DRAFT CONSENT CONDITIONS (PROPOSED BY APPLICANT)

The Car Distribution Group

INFORMATION REQUEST RESPONSE RE 13.07.17

JOHNS ROAD CAR STORAGE PROJECT – SECTION 92 RESPONSE – ENGINEERING MATTERS

APPENDIX 1:
Proposed Development Plans

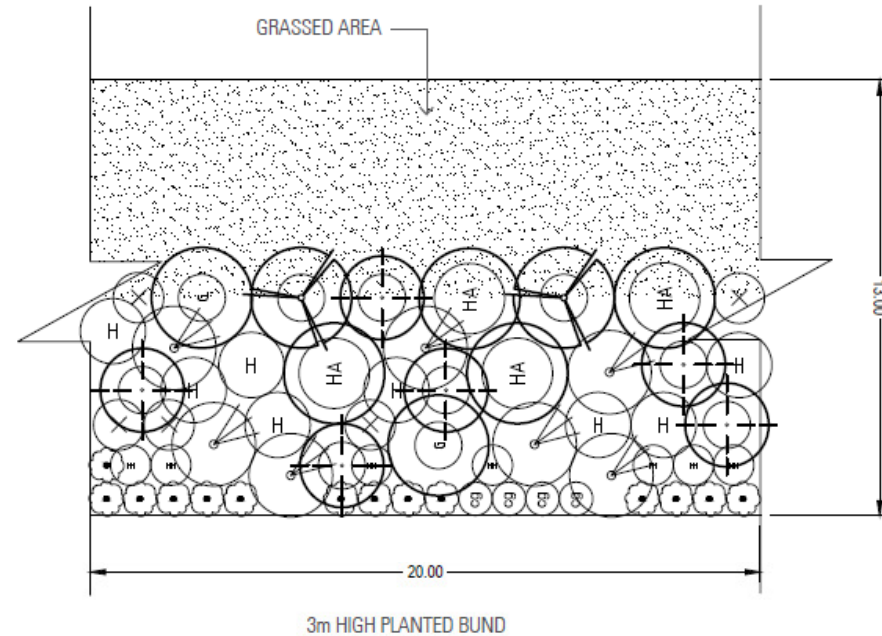
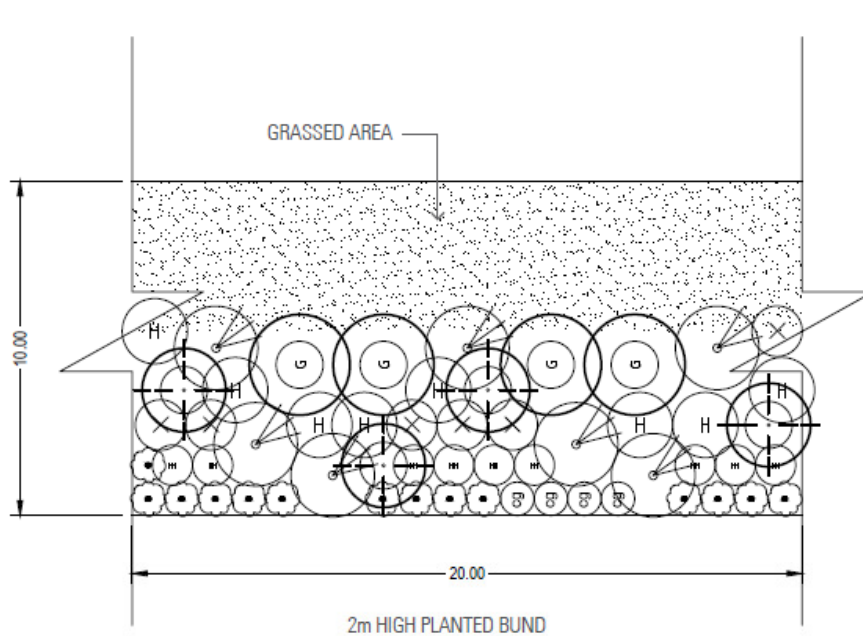
As the proposed earthworks involve general levelling of the site, no excavations will occur below the present minimum site elevation. Current site elevations range from approximately 31 to 35 metres above sea level (m asl) (see Attachment 1 – Existing Site Contours). The proposed site elevations range from approximately 33 to 35 m asl (see Attachment 2 – Cut and Fill Plan).

No material is planned to be brought on to the site with the exception of virgin quarry material to help construct the permanent hard standing. A cut of 36,000 m³ is planned for the site (see Attachment 2 – Cut and Fill Plan); the material will be re-used on-site as fill.
